MEMORANDUM

From: Chief Officer, Environment & Technical **To:** Chief Officer Planning & Regulatory
Our Ref: PR/DC/P/2019/0348 **Your Ref:** MP/P/2019/0348
Date: 21st October 2019

Location: O. S Grid Ref: 331 496 Oak Tree Tavern, 45 to 47 Ruabon Road, Wrexham.
Development: Conversion of former public house and associated flat into 3 no. two-storey dwellings and erection of 3 no. new detached dwellings to rear.

I refer to your consultation dated 03/10/2019 including layout plan (Drg. No. 2224/105 Rev A) in respect of the above.

- 7.5t Panel Van
- Overall Length
- Overall Width
- Overall Body Height
- Min Body Ground Clearance
- Track Width
- Lock to Lock Time
- Kerb to Kerb Turning Radius

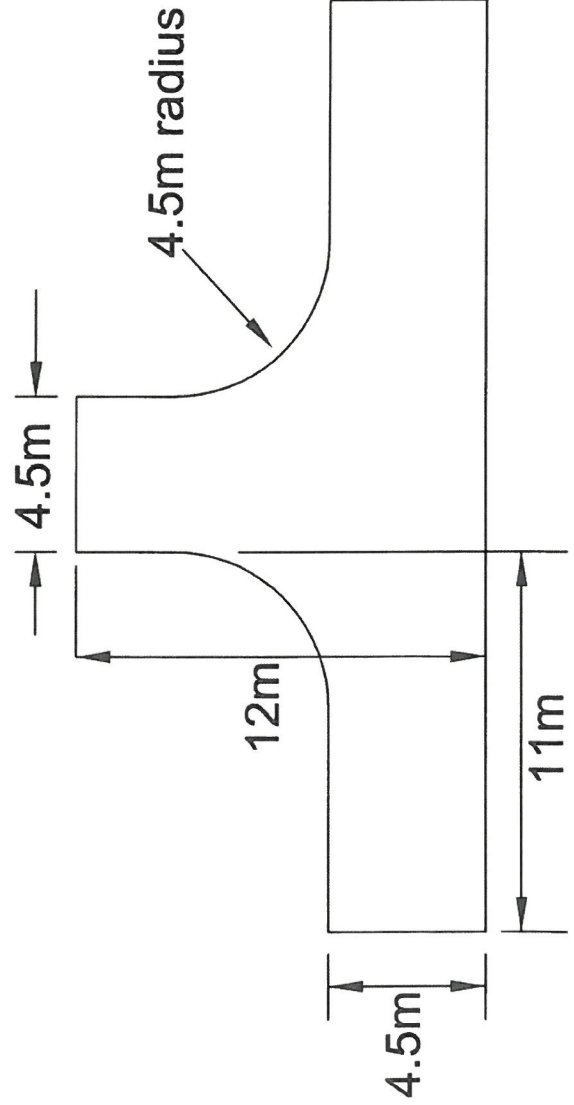
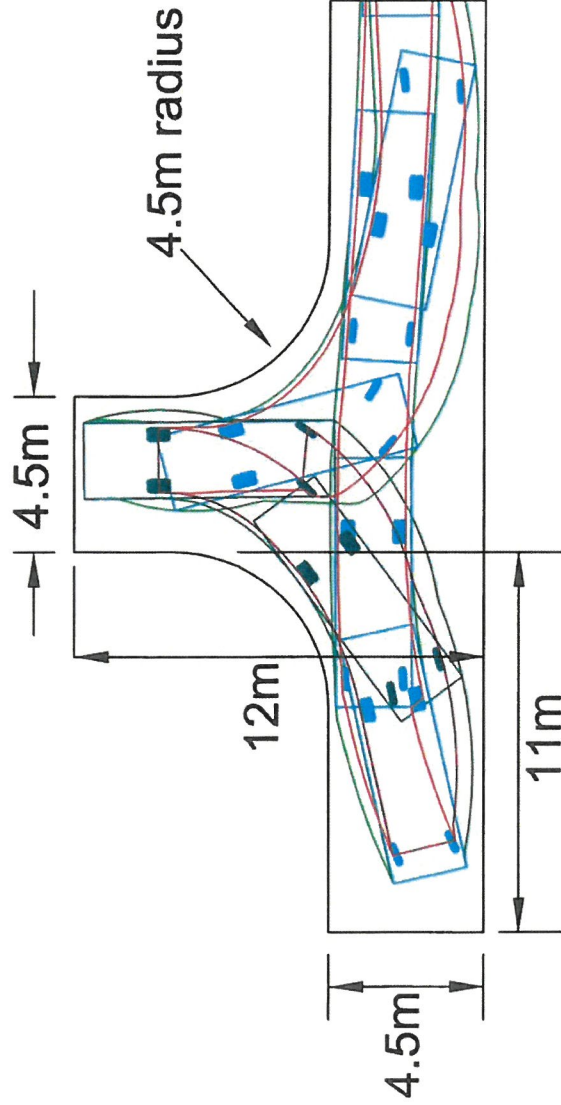
There would currently appear to be sufficient space within the car park to accommodate the turning movements of smaller delivery vehicles / dray wagon. The submitted layout does not provide such a turning facility which is considered unacceptable. This means that all vehicles other than cars will have to service the site from the main road.

I would recommend that the applicant re-considers the parking and turning arrangements in order to provide a turning area which can accommodate the turning movements of a medium sized delivery vehicle (see attached detail).

I would normally recommend that the applicant submits a suitably scaled layout plan indicating this detail for further consideration.
